Economic Development and Planning
Ribble Valley Borough Council
Council Offices
Church Walk
Clitheroe
BB7 2RA

Your ref 3/2021/0660-0661
Our ref 3/2021/0660-0661/NJS2
Date 17th February 2023

Application No: 3/2021/0660 AND 3/2021/0661
Location: BOWLAND SECTION AND MARL HILL SECTION. WORKS AT VARIOUS LOCATIONS.
Proposal: PROPOSED WORKS FOR AND USE OF REPLACEMENT SECTION OF AQUEDUCT, INCLUDING EARTHWORKS AND ANCILLARY INFRASTRUCTURE INCLUDING: A NEW VALVE HOUSE BUILDING WITHIN FENCED COMPOUND WITH PERMANENT VEHICULAR ACCESS PROVISION. WITH THE INSTALLATION OF A TUNNEL PORTAL AND AN OPEN CUT CONNECTION AREA WITHIN A TEMPORARY CONSTRUCTION COMPOUND, TO INCLUDE SITE ACCESSES, STORAGE AREAS, PLANT AND MACHINERY, AND DRINAGE INFRASTRUCTURE AND A TEMPORARY HAUL ROUTE WITH BRIDGE OVER THE RIVER HODDER. IN ADDITION, A TEMPORARY HAUL ROUTE WITH BRIDGE OVER THE RIVER RIBBLE (AS ONE OF TWO OPTIONS FOR VEHICULAR ACCESS TO THE TEMPORARY CONSTRUCTION COMPOUND); A SERIES OF LOCAL HIGHWAY WORKS TOGETHER WITH A TEMPORARY SATELLITE PARK AND RIDE FACILITY AND A VEHICLE MARSHALLING AREA.

Summary

The routes are highlighted in the diagram below.

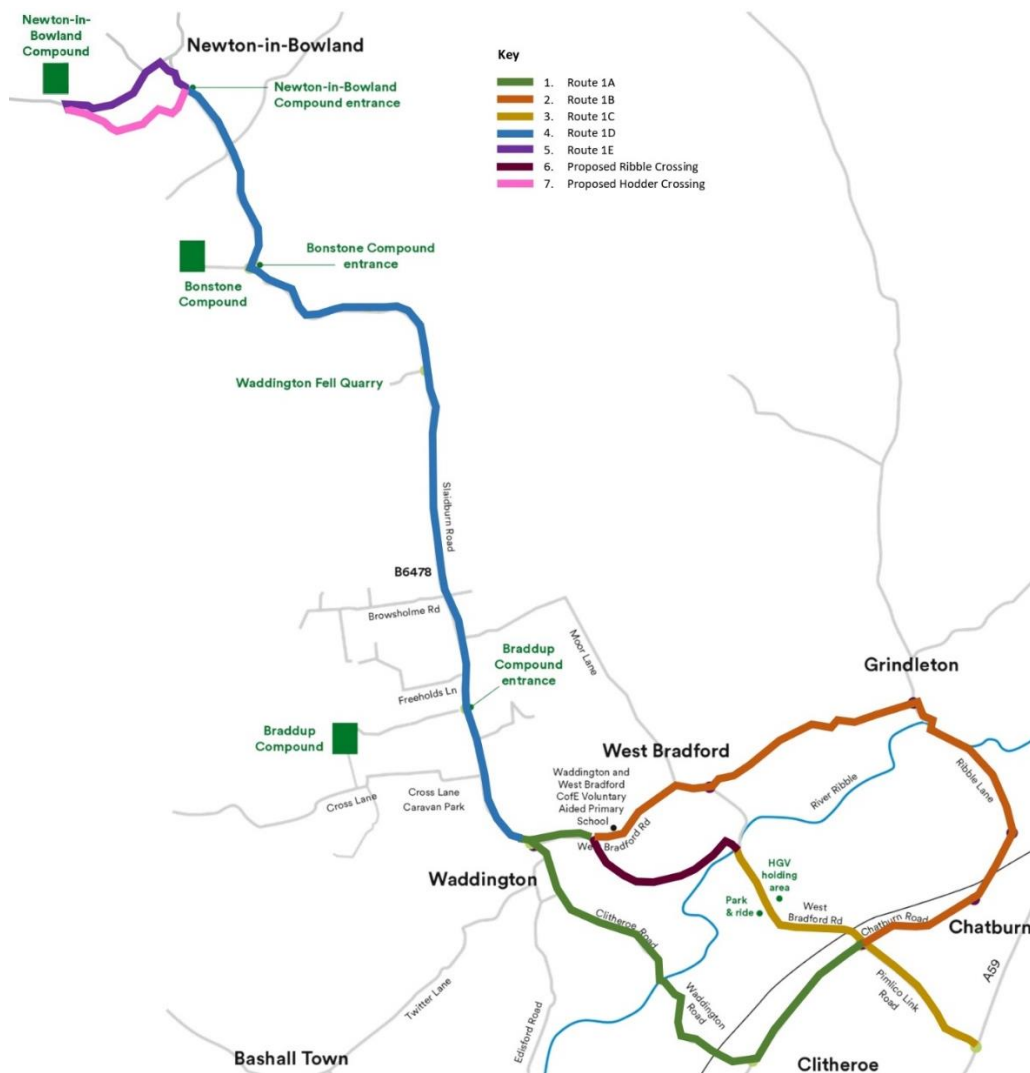
The proposal for Route 1 can be divided in to 5 sections.

- Route 1A: (for vehicles under 3.5m high) to access the northern end of the proposed Ribble Crossing
- Route 1B: (for vehicles over 3.5m high) to access the northern end of the proposed Ribble Crossing
- Route 1C: to access the southern end of the proposed Ribble Crossing.
- Route 1D: extension to Routes 1A and 1B to access the B6478 for the eastern side of the proposed Hodder Crossing.
- Route 1E: is proposed to access the western side of the proposed Hodder Crossing.

Note: the CTMP will need to identify how the risk of vehicles not using the current route and how this will be managed (i.e., tractors being interchangeable with trailers).
